Subject: Second Draft of Order No. R8-2009-0030 NPDES No. CAS618030

Date: 9 April 2009
To: Mary Anne Skorpanich, Director, OC Watersheds Program
cc: Jeff Pratt, Public Works Director, County of Ventura
From: Eric Strecker, P.E. and Aaron Poresky, E.I.T. Geosyntec Consultants
Malcolm Walker, P.E. Larry Walker and Associates
Subject: Response to Critical Comments on "Low Impact Development Metrics
in Stormwater Permitting"

Figure 1: Comparison of precipitation and ET patterns between western Texas and southern California

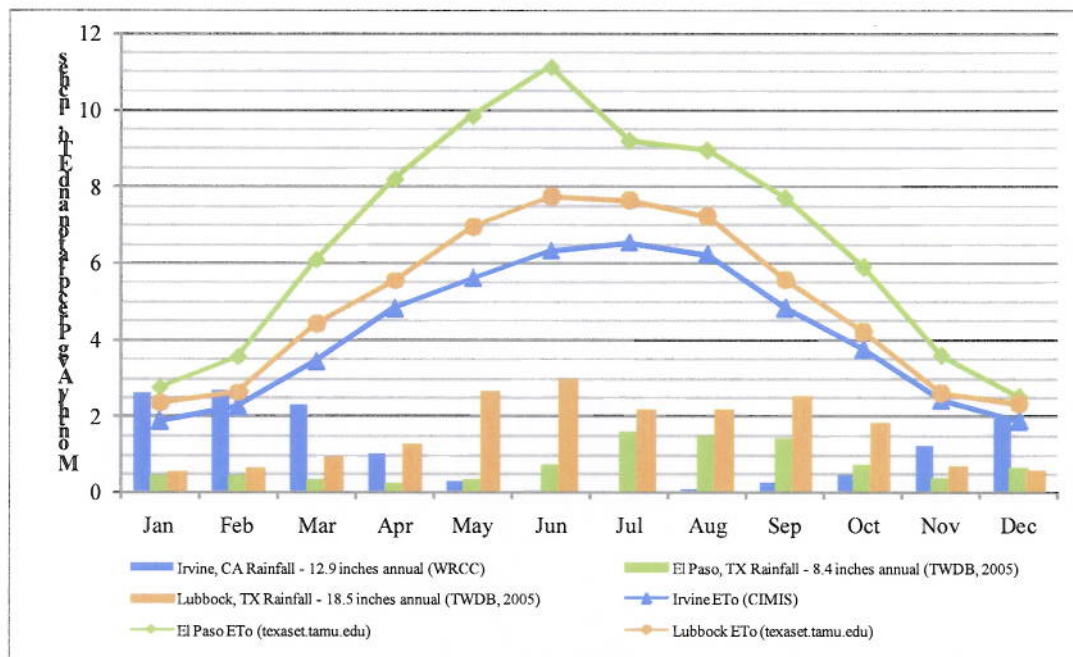
The critique refers to an established program of rainwater harvesting and reuse in Texas. While eastern Texas receives greater rainfall than Southern California, the critique states that western Texas “has rainfall conditions very much like southern California’s”. A detailed review of the Texas Rainwater Harvesting Guidelines (TWDB, 2005) showed that this program is primarily targeted toward using harvesting to meet water demands, not to control stormwater. It should also be noted that large parts of Texas receive summer rainfall in the form of thunderstorms which rarely, if ever, occur during the summer in Southern California. Figure 1 provides a summary comparison between precipitation and evapotranspiration patterns in western Texas versus southern California.

Based on this preliminary comparison, western Texas appears to be a more favorable location than southern California for rainwater harvesting to manage stormwater impacts and meeting water demands. First, periods of higher rainfall are coincident with periods of higher ET in west Texas, while the opposite is true in southern California. Second,

rainfall occurs more steadily throughout the year in west Texas compared to the normally dry spring, summer and fall months of southern California.

Figure 2: Monthly normal patterns of ET and precipitation at Reagan National Airport

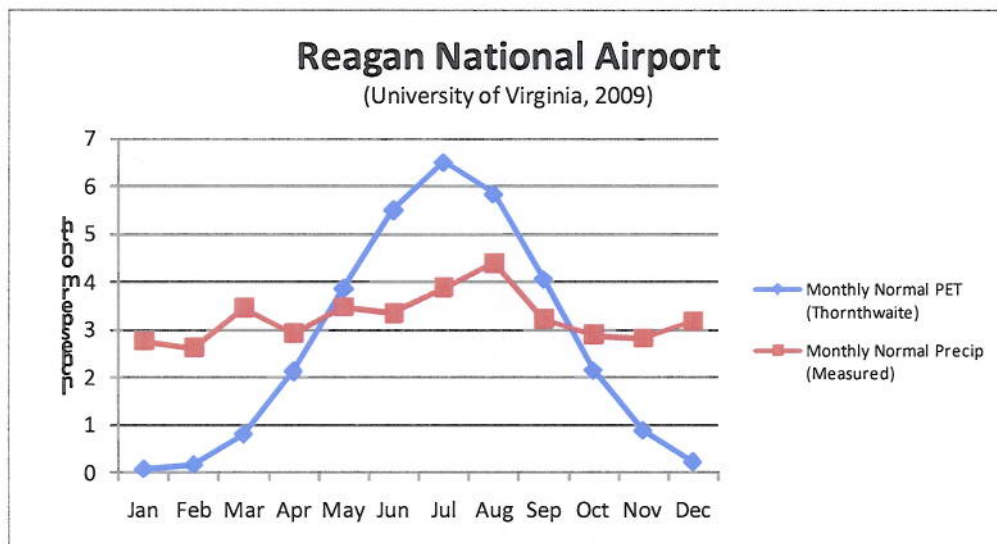
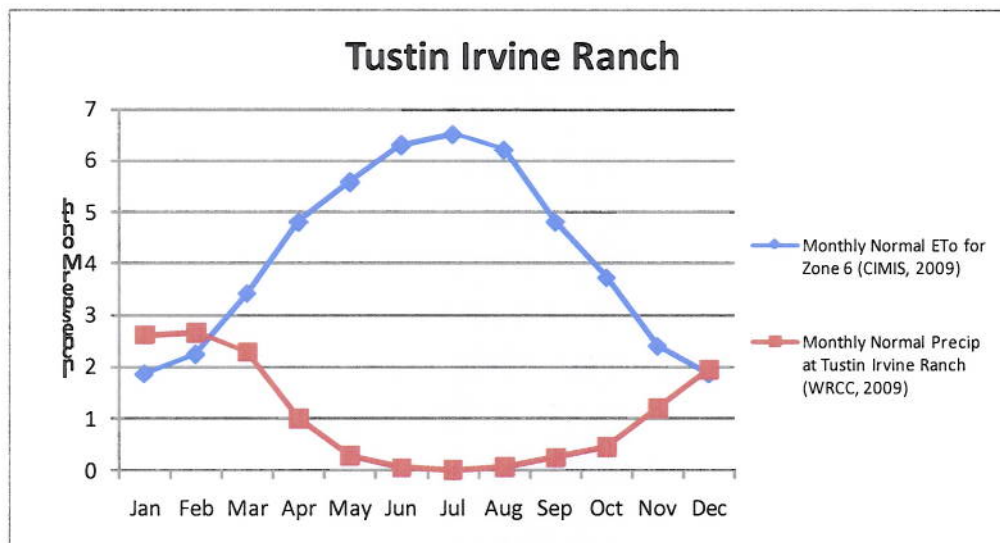
- 3.8 **60 California – anticipated performance of greenroofs and cisterns.** The critique provides a somewhat vague defense for the performance of greenroofs in Southern California. One cited study found that a greenroof in Pennsylvania could reduce average annual runoff volumes by 50 percent. This study was compared to Southern California by saying that pan evaporation rates are between 3.3 and 4.2 inches per month in Pennsylvania from June to September (presumably a wet season in that locale) while November – February pan evaporation ranges from 3.5 to 4.0 in Los Angeles. A review of local ET data in Los Angeles County showed that this comparison is not valid. Monthly ET rates in Southern California range from about 1.5 to 2.5 from November through February. Also, rainfall is more seasonally concentrated in Southern California than in the mid-Atlantic region. Figures 2 and 3 below provide a comparison between Irvine, CA and the Washington, DC vicinity, for example.

Dr. Horner states: “Therefore, Los Angeles has as much evaporation potential in the months when it most needs that potential as locations with successful green roofs elsewhere.” Figure 2 shows that ET rates in December, January, and February are lower than the average precipitation. As precipitation is rarely average, on frequent occasions rainfall rates will significantly exceed ET rates. Thus Dr. Horner’s conclusion does not seem to be supported by the examples provided.
